CITY OF ALBUQUERQUE

**RE: Desert Springs Church – Parking Addition
705 Osuna Rd. NE
Grading and Drainage Plan
Engineer’s Stamp Date: 07/08/21
Hydrology File: E16D021**

Based upon the information provided in your submittal received 07/13/2021, the Grading & Drainage Plan is **not** approved for Grading Permit and Paving Permit. The following comments need to be addressed for approval of the above referenced project:

C-100

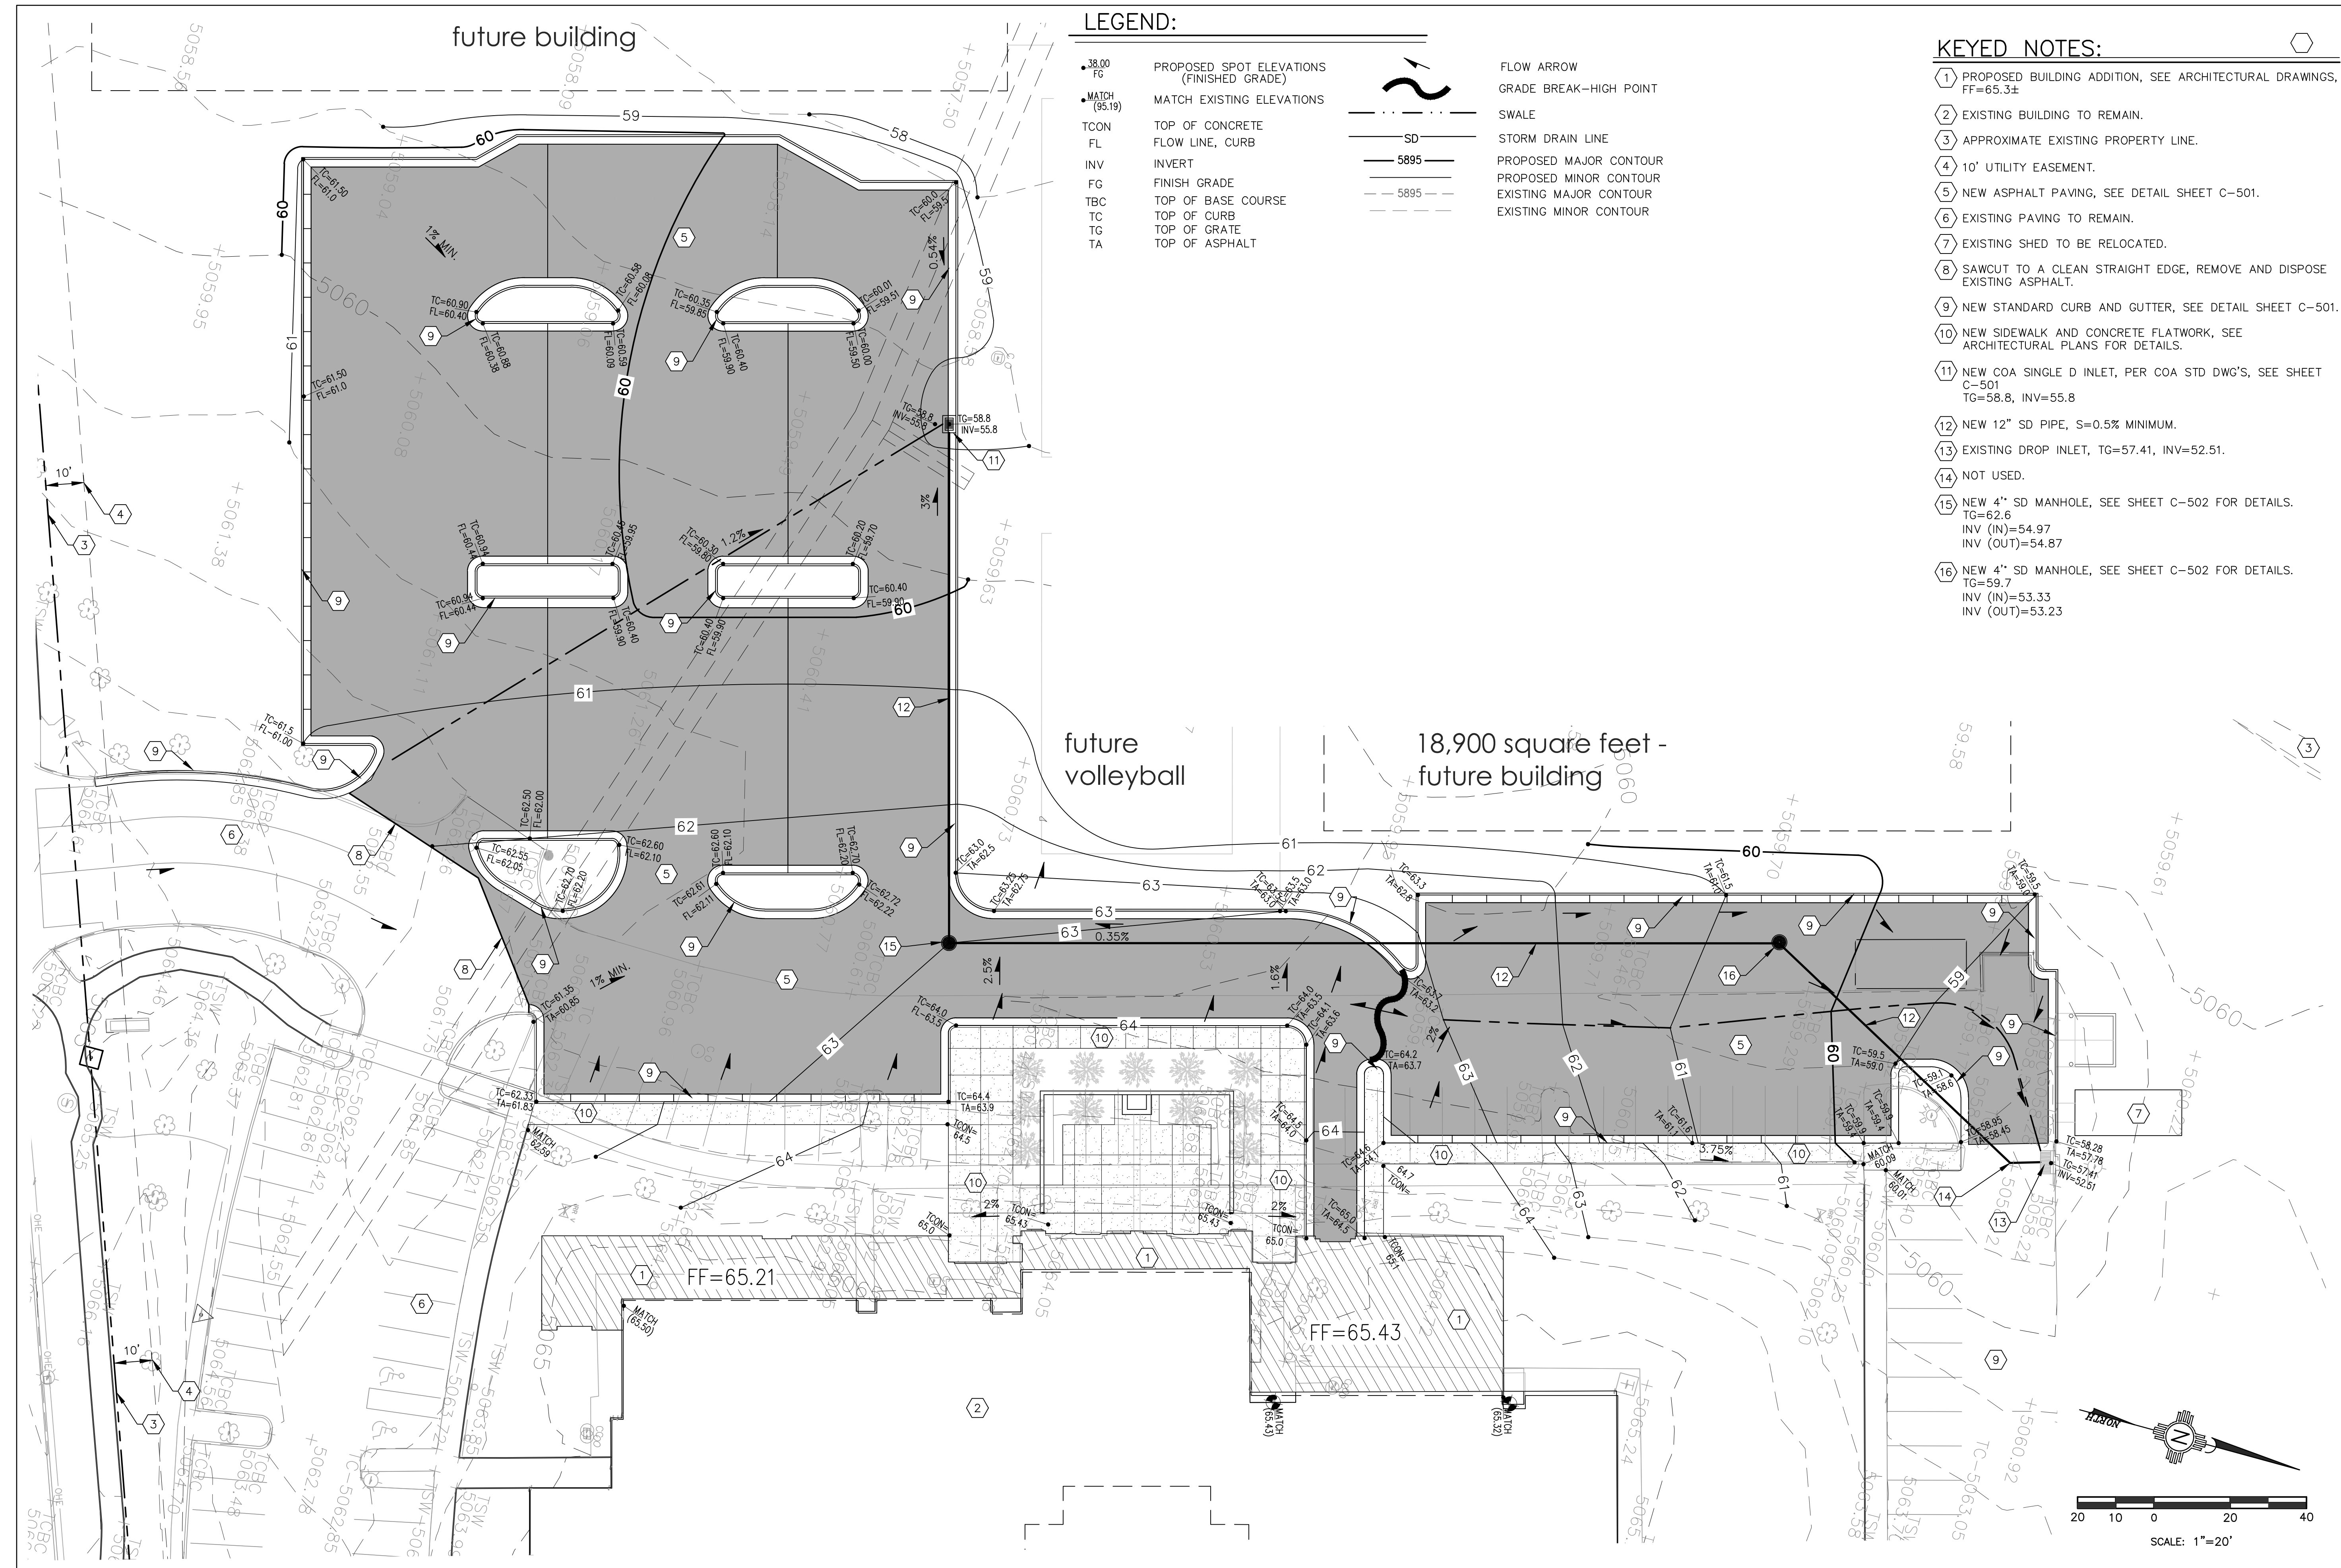
1. According to the Agave Subdivision (E16D024) the storm sewer capacity allowed a Q_{100} of 39.3 cfs for the Church property. (See calculation below) Since the Proposed Q_{100} is 40.467 cfs, a detention will have to be designed. When designing this, please think about all the future developments for this site and ensure that the future Q_{100} will have room to expand the planned detention facility.

2. Since a detention facility will be needed, the required stormwater volume will be included in the detention facility.
3. If a detention pond is going to be planned, then please add the following note, "Pond side slopes need to be stabilized with Native Grass Seed with Aggregate Mulch or equal (Must satisfy the "Final Stabilization criteria" CGP 2.2.14.b.)".
4. As a reminder, if the project total area of disturbance (including the staging area and any work within the adjacent Right-of-Way) is 1 acre or more, then an Erosion and Sediment Control (ESC) Plan and Owner's certified Notice of Intent (NOI) is required to be submitted to the Stormwater Quality Engineer (Doug Hughes, PE, jhughes@cabq.gov , 924-3420) 14 days prior to any earth disturbance.
5. Standard review fee of \$150 will be required at the time of resubmittal.
